Access Compliance Report

Public Rights-of-Way

Intersection ID: N/A	Main Street: CITY_PARK_DR	Cross Street: N/A	Location: SE
ADA ID: 32AAD3697BB3	Ramp Type: Perp	Initial Pass/Fail: Pass	Overall Compliance: No
		Severity Score: 10

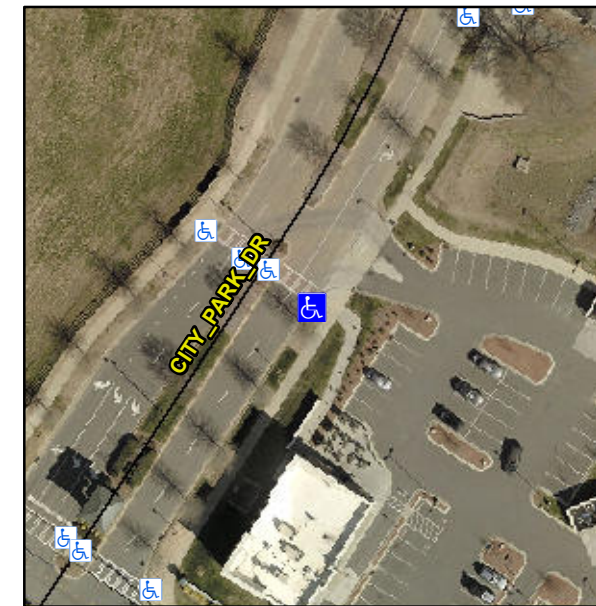
R304.2.3, R304.5.4

Compliance	Description	Data	Compliance	Description	Data
N/A	Ramp Length (in)	95.0	Yes	Ramp Slope (%)	7.4
Yes	Ramp Width (in)	94.0	Yes	Ramp XSlope (%)	1.2
No	Flare Type	Curbed_WithWalkSurface	Yes	Flare Type RT	N/A
No	Flare Slope LT (%)	N/A	N/A	Flare Slope RT (%)	N/A
N/A	Flare Traversable LT?	No	N/A	Flare Traversable RT?	No
Yes	Landing Length (in)	71.0	Yes	DWS Provided?	Yes
Yes	Landing Width (in)	94.0	Yes	DWS Contrast?	Yes
Yes	Landing Slope (%)	1.1	Yes	DWS Length (in)	24.0
Yes	Landing X Slope (%)	0.5	Yes	DWS Full Width?	Yes
N/A	Landing Curb? (Y/N)	No	Yes	DWS Offset (in)	0.0
N/A	Shared Landing?	No			
Yes	Gutter Ponding?	No	No	Gutter Slope (%)	8.5
Yes	Gutter Lip Ht (in)	0.0	Yes	Gutter X Slope (%)	0.7
N/A	Painted X Walk1?	Yes	N/A	Painted X Walk2?	N/A
	X Walk 1 Direction	To NW		X Walk 2 Direction	N/A
N/A	X Walk 1 Width (in)	90.0	N/A	X Walk 2 Width (in)	N/A
	X Walk 1 Slope (%)	4.1		X Walk 2 Slope (%)	N/A
	X Walk 1 X Slope (%)	0.7		X Walk 2 X Slope (%)	N/A

**Remove & Replace Curbed Edge.
Remove & Replace Gutter.**
